RAI No.: 47

**BELL BEND NUCLEAR POWER PLANT
RESPONSE TO RAI No. 47
BNP-2009-292 Docket No. 52-039**

The enclosure provides our response to RAI No. 47, Questions 13.03-2 through 13.03-14, which includes revised Evacuation Time Estimate (ETE) Report (COLA Part 5) content. These changes will be incorporated in a future revision of, or supplement to, the COLA upon revision of the ETE Report. This future revision of, or supplement to, the COLA is the only new regulatory commitment.

Response to NRC Request for Additional Information No. 47
Bell Bend Nuclear Power Plant

Figure 2-1. Assumed Evacuation Response

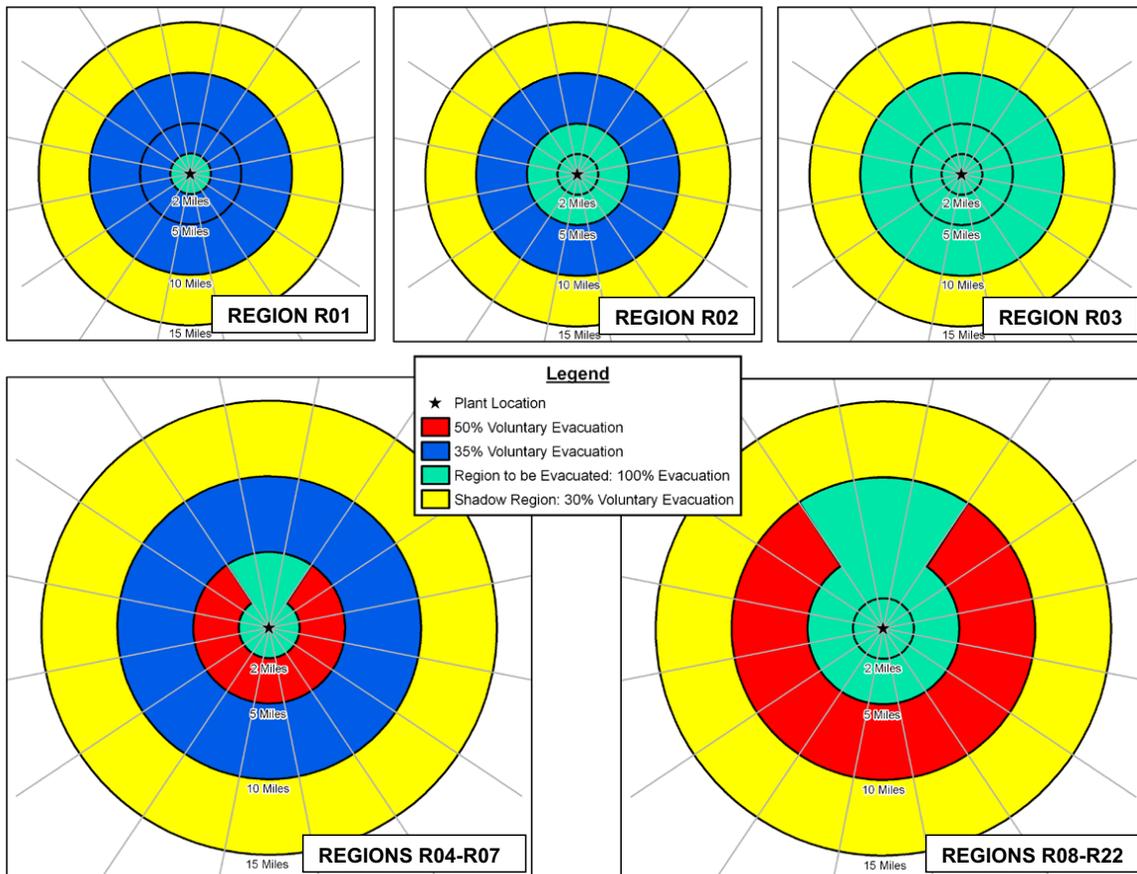
- A. Section 2, "Study Estimates and Assumptions," states that in Figure 2-1, "Assumed Evacuation Response," the area which is within the EPZ but outside the evacuation region (Regions R08-R22), will have a voluntary evacuation of 50 percent. Figure 2-1 (Regions R08-R22) shows a 35 percent voluntary evacuation rate for this area. Clarify whether the blue area depicting Regions R08-R22 in Figure 2-1 will have a 35 percent or 50 percent voluntary evacuation rate.

A. The text in assumption 4 of Section 2.2, "Study Methodological Assumptions" is correct, stating that 50 percent of the population within the EPZ but outside the evacuation region will elect to voluntarily evacuate. For consistency with the other figures, the text will be modified to indicate that this area is red, and Figure 2-1 will be modified so that the area in question will be shaded red instead of blue.

2. Figure 2-1 will be replaced with the attached figure in a future revision of the ETE Report.

Figure 1 – School Bus Evacuation Route

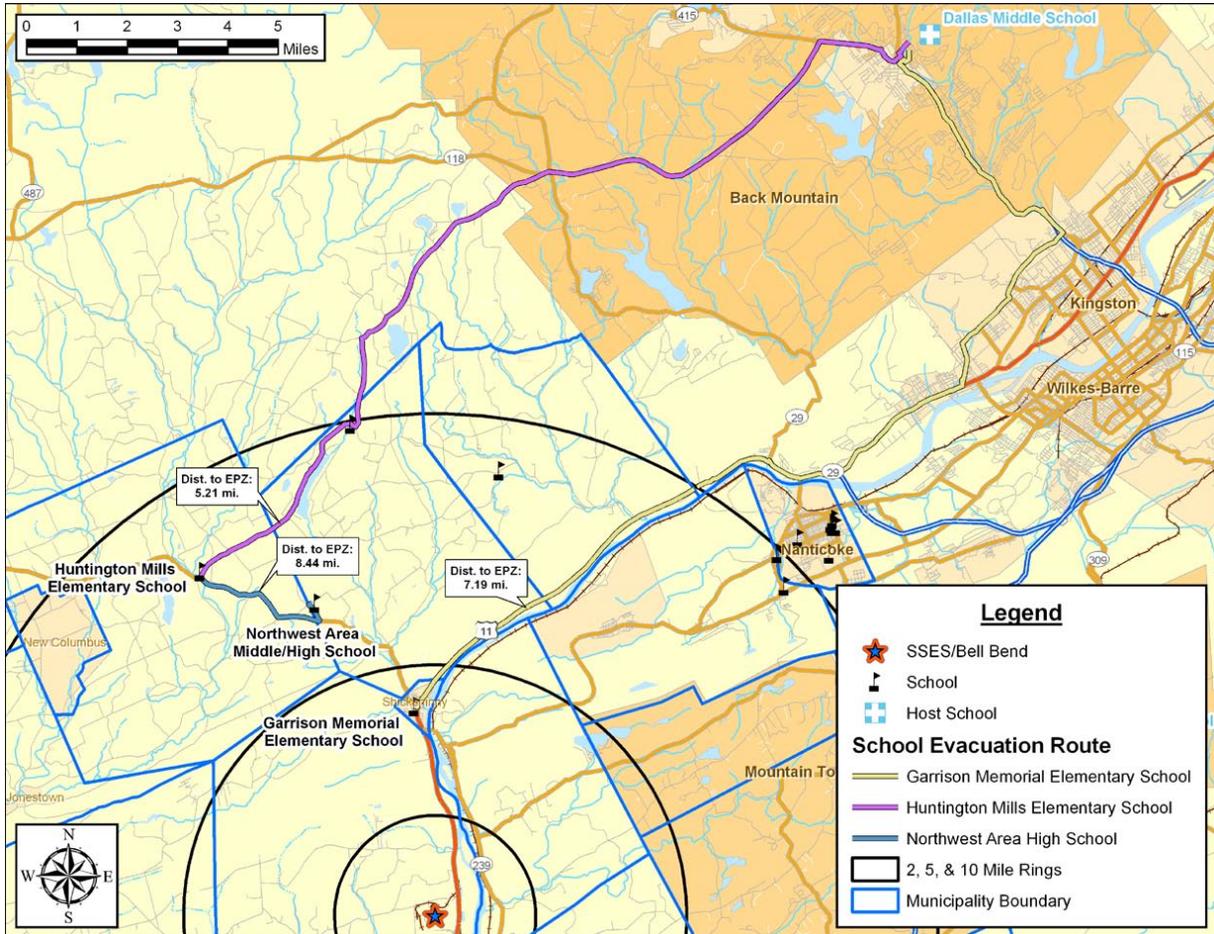
- A. Table 8-5A, "School Evacuation Time Estimates – Good Weather," indicates that the distances from Garrison Memorial Elementary School, Huntington Mills Elementary School and Northwest Area High School to the EPZ boundary is 11 miles. Discuss how traveling these distances through the EPZ reflects a generally radial evacuation, as recommended in NUREG 0654. Revise the ETE report as needed.

The attached Figure 1 shows the likely evacuation routes between the three cited schools and the host, Dallas Middle School. As presented in Figure 1, the lengths of the routes between these schools and the EPZ boundary are 7.2 mi, 8.4 mi and 5.2 mi. These routes which are generally outbound relative to the location of the nuclear power plant will be updated in a future revision of the ETE study, along with the ETE in Tables 8-5A and 8-5B.

1. Tables 8-5A and 8-5B will be updated in a future revision of the ETE Report with the updated evacuation route distances.
